Clay Preshaw - RE: Wallarah 2 Coal Project - Response to Submissions

COMMENTS RE WALLARAH 2 COAL PROJECT RESPONSE TO SUBMISSIONS REPORT

**Wallarrah 2 Coal Project (SSD 4974)
Comment on the Response to Submissions Report**

RE: REVIEW OF THE RESPONSE TO SUBMISSIONS REPORT FOR THE WALLARAH 2 COAL PROJECT (SSD-4974)

Map 1 Modelled Water Table depth in Jilliby State Conservation Area

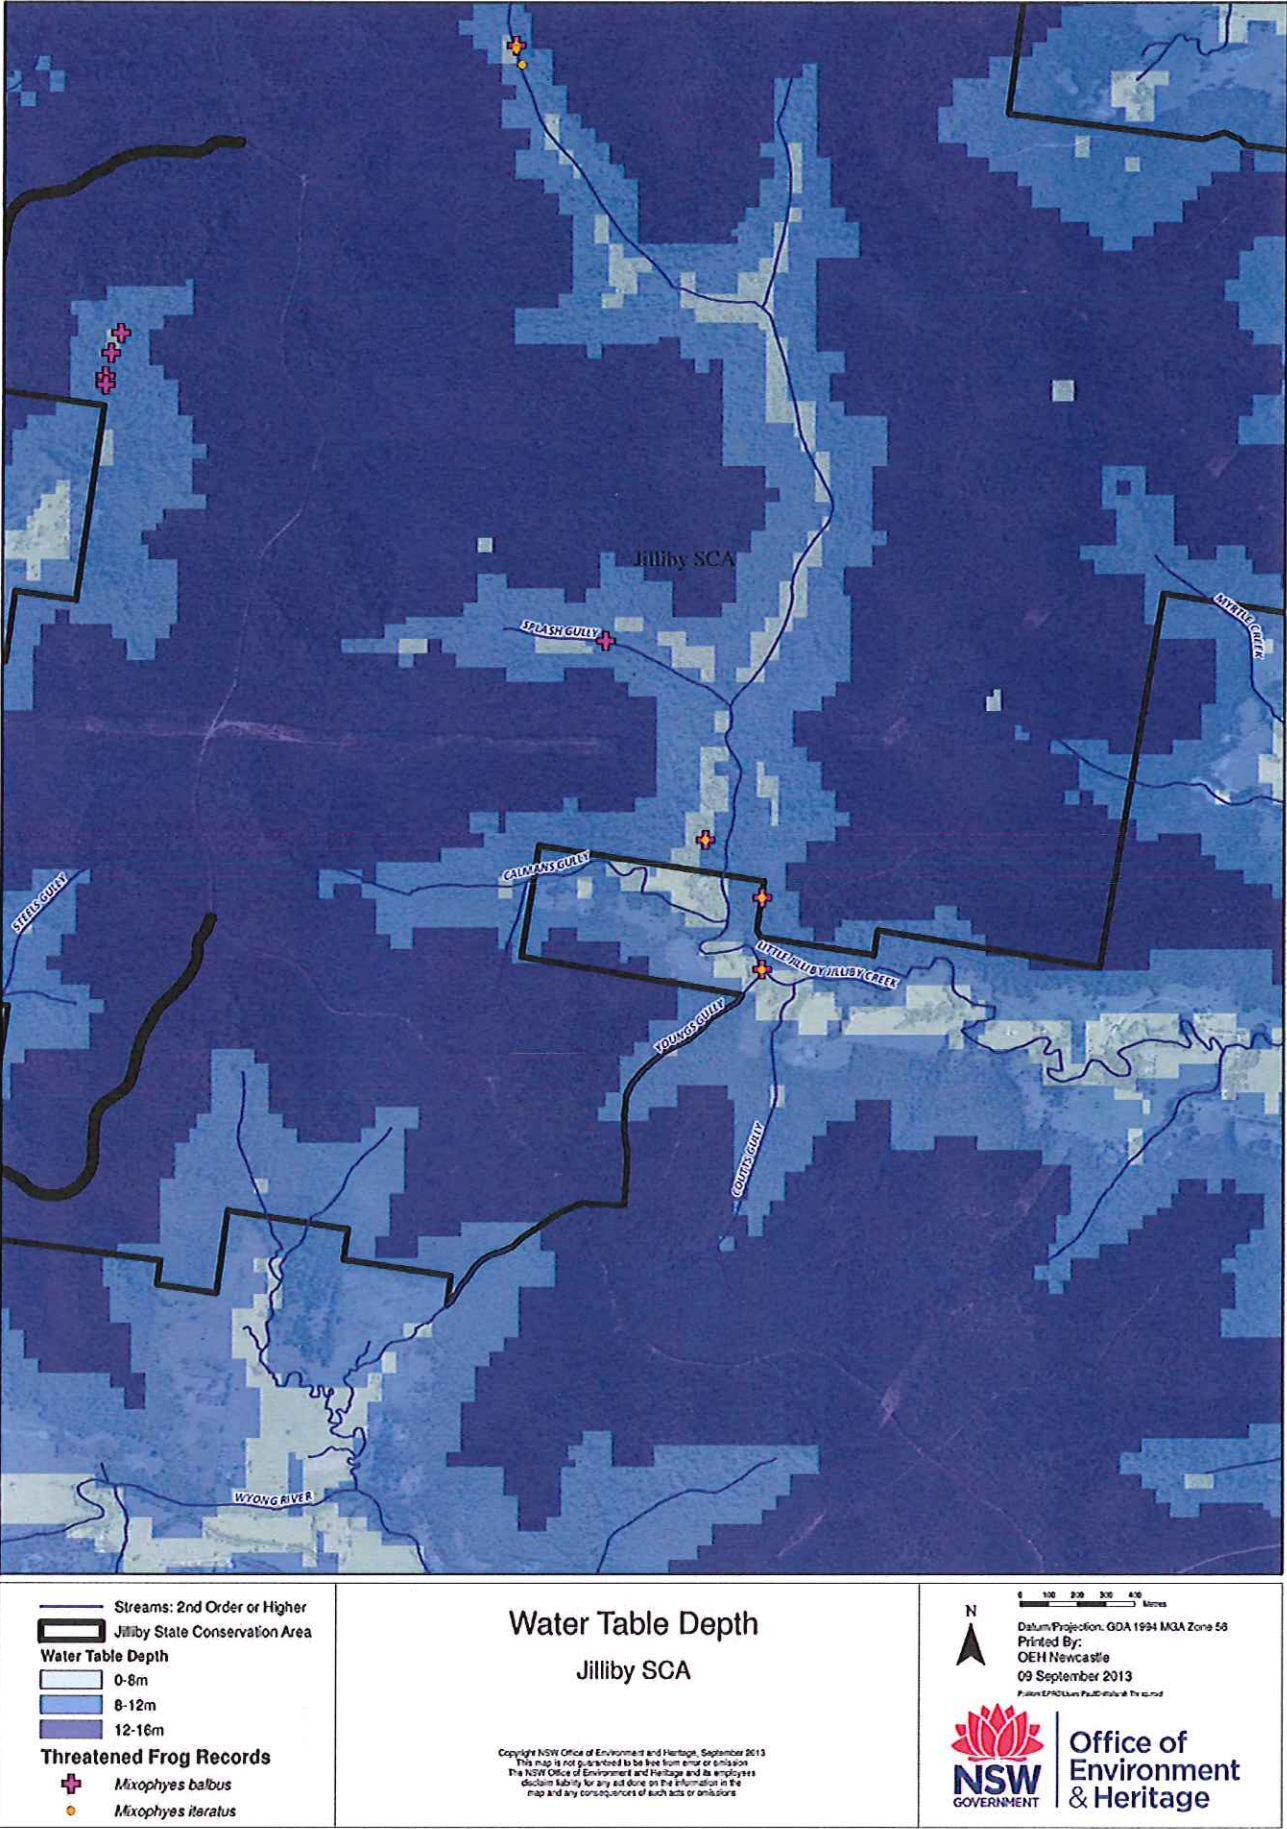
OEH acknowledges that the geological profile in the Project Area varies considerably from a wide river valley with a shallow layer of alluvium to more upland areas within the public lands to the west with a layer of Narrabeen Sandstone (Terrigal Formation) over laying. It is reasonable to say that given the geological differences between the different mining provinces, particular precaution must be exercised when predicting impacts upon surface and shallow aquifer systems.

Updated groundwater modelling (W3) indicates there would be some cracking of the shallow hardrock allowing some water loss from shallow aquifers and also cracking in the fractured zone above the extraction but that these two zones would not meet. While no evidence of significant faulting has been presented in the EIS, similar geological reports indicate that the presence of two linaments intersecting or adjacent to the project area (NOW submission July 2013). This would suggest the degree of certainty that the deep and shallow aquifers will remain separated is questionable.

Under this option, the current mine plan is to be modified to avoid possible impacts from subsidence upon all 3rd order and larger streams and groundwater-dependent ecosystems in the Jilliby SCA, taking into account the angle of draw of the longwall panels. This would mean no direct undermining of Little Jilliby Jilliby Creek or other 3rd order streams as currently planned. Specific modifications would include an alteration of the mine layout, including location of long walls, total area, length, width of excavation and pillar areas.

Map 2: Distribution of Lowland Rainforest EEC

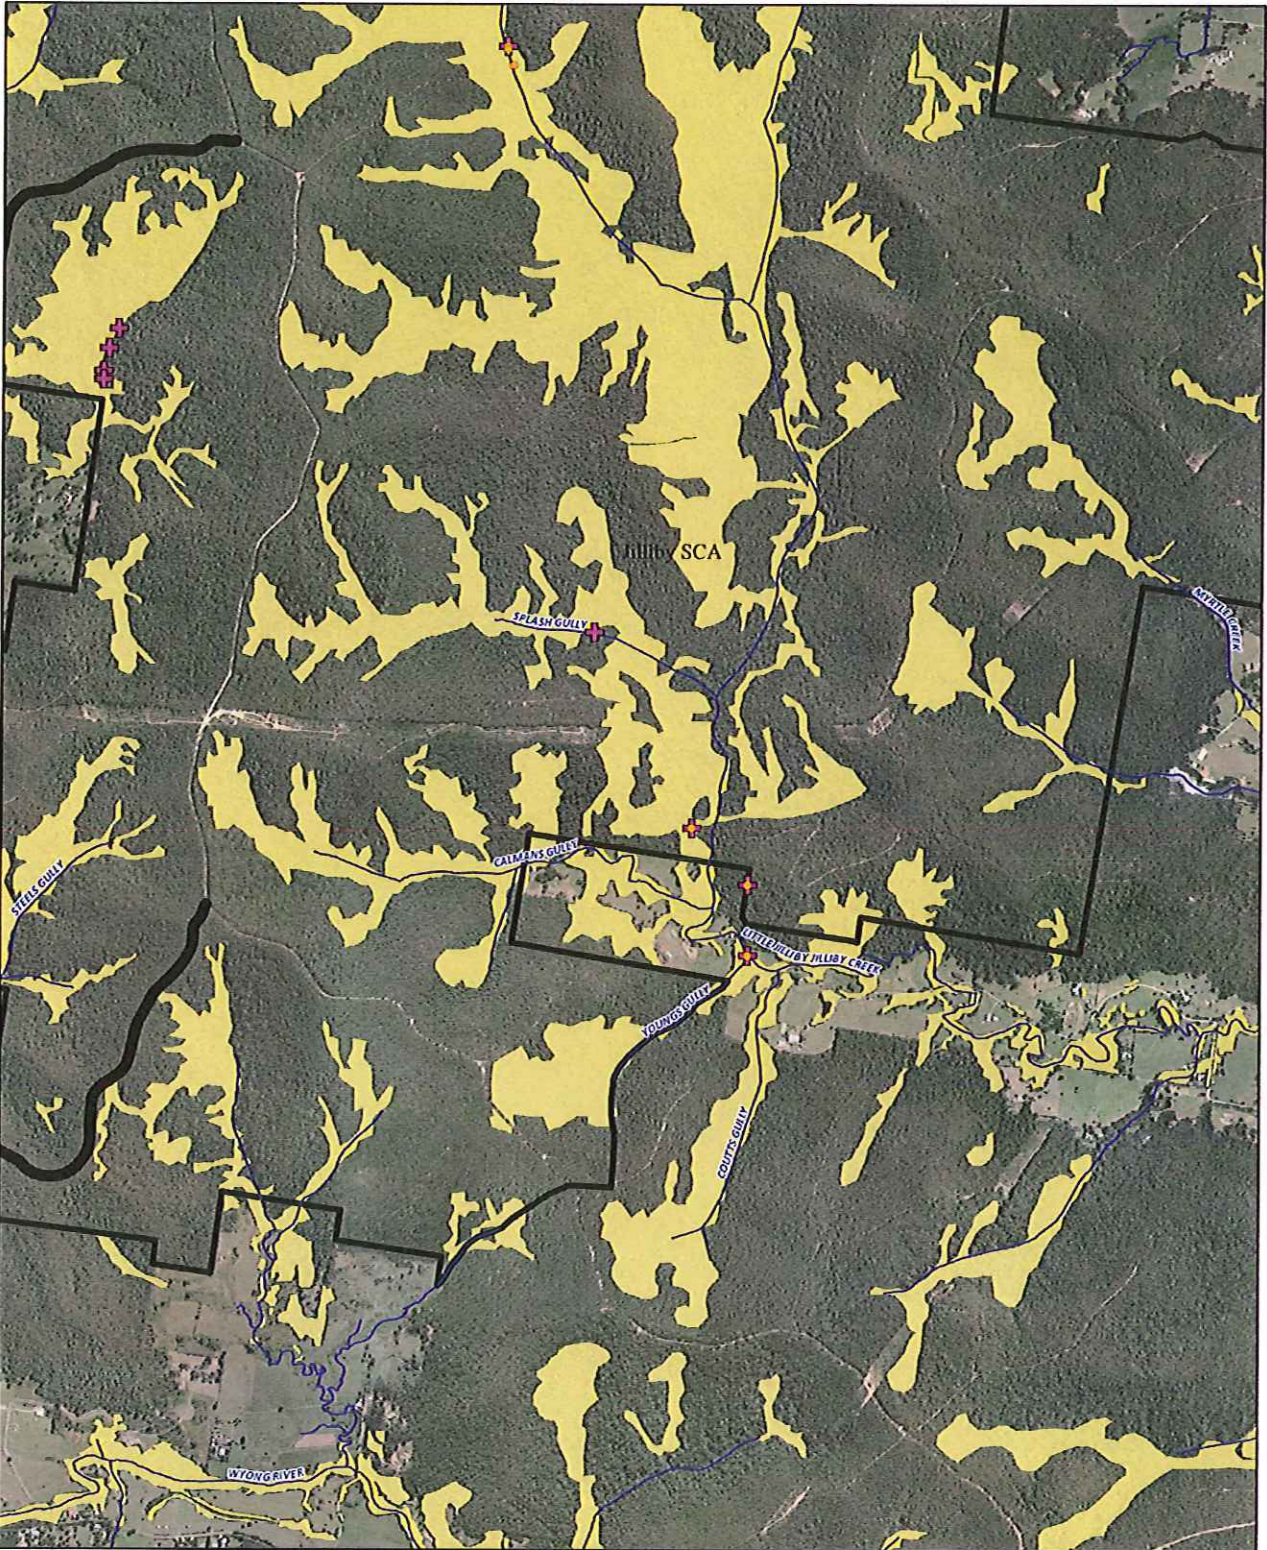
OEH Regional Operations has had two meetings with respect to this project, one with the proponent (13 August 2013) and one with the Department of Planning and Infrastructure (DP&I) (11 September 2013). Following the review of the RTS, the main issues that are of concern for OEH are related to the risk to threatened biodiversity both within Jilliby State Conservation Area (SCA) and the wider Project Area and potential for permanent damage to aquifers and surface water systems which support this threatened biodiversity a result of mine subsidence.

Map 3: High probability GDEs in Jilliby State Conservation Area

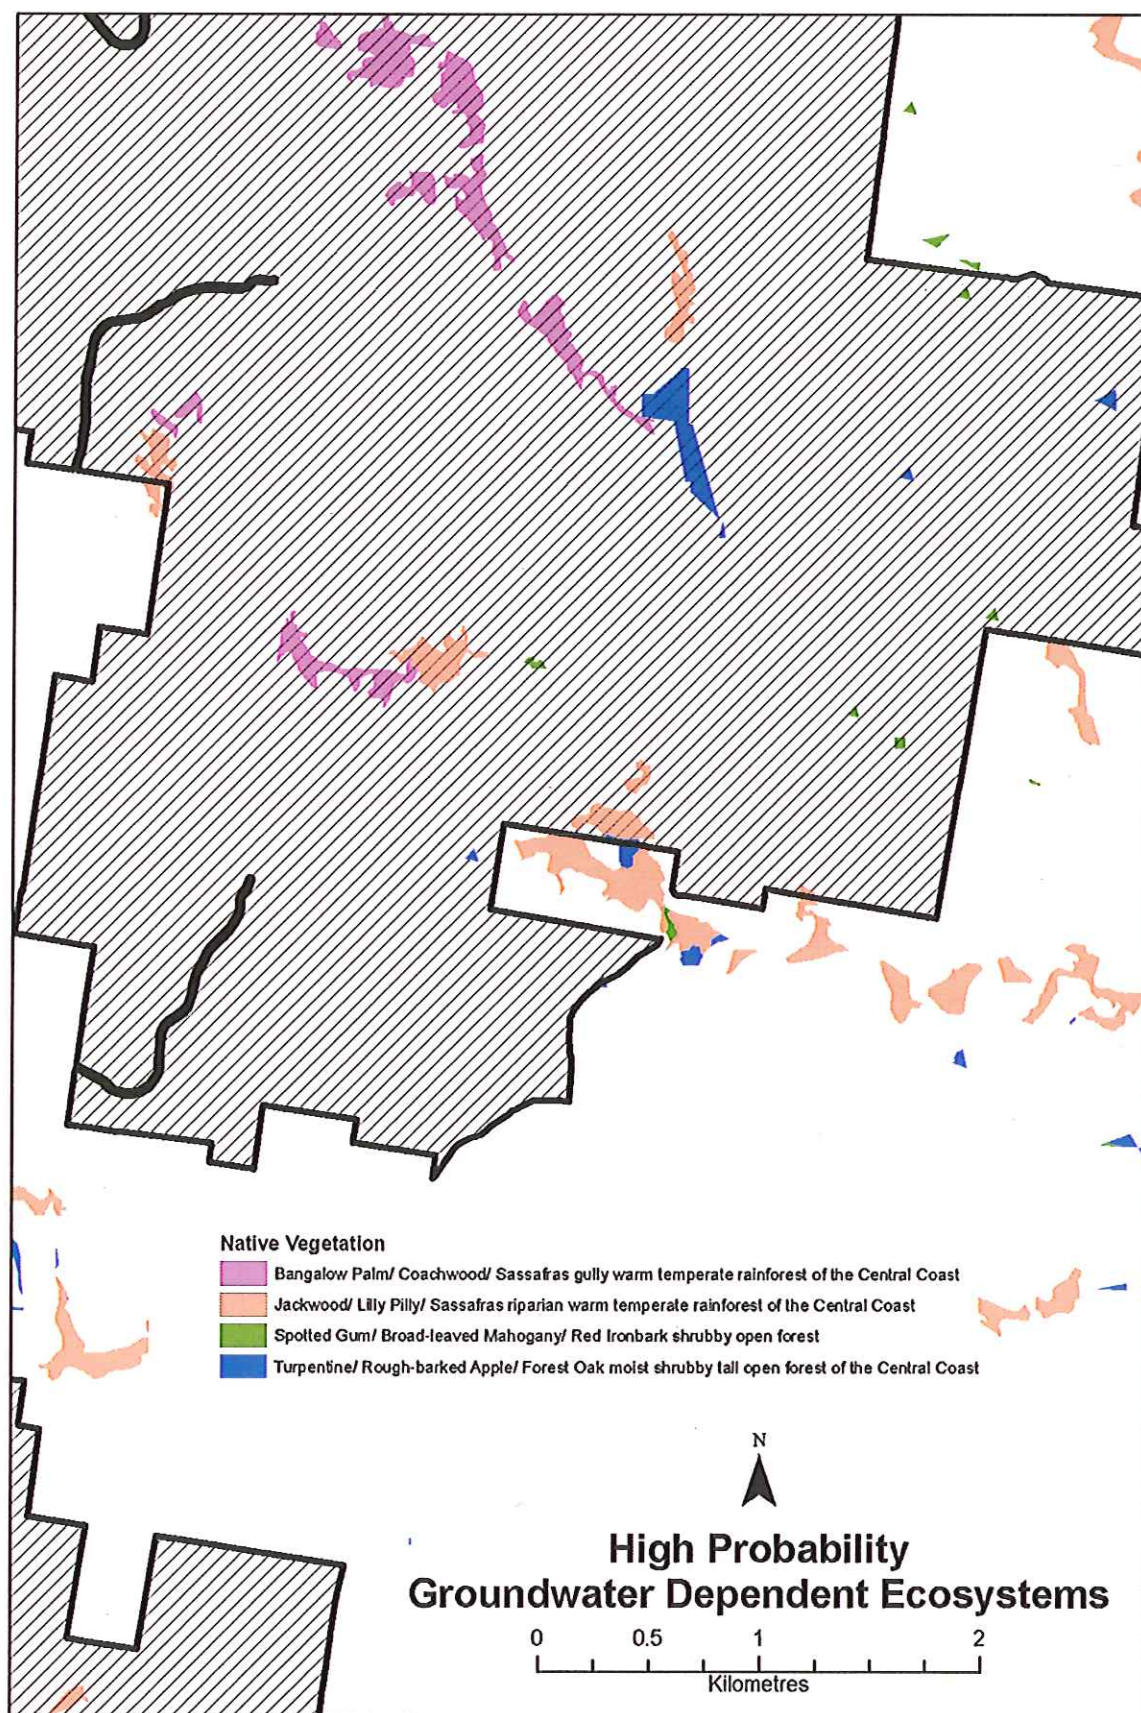
- *"Cumberland Ecology has identified a number of groundwater dependent ecosystems within the vicinity of the major and minor drainage systems within the Project Boundary, including areas of the Jilliby SCA. In these areas, the water table within the hard rock strata is predicted to be deep. The trees and plants within the Jilliby SCA are unlikely to draw moisture from the deeper hard rock groundwater systems that are predicted to be affected by the Project. Instead, they are expected to rely upon soil moisture within the unsaturated zone, which is presently sustained by rainfall and runoff and will continue to do so with the Project."*
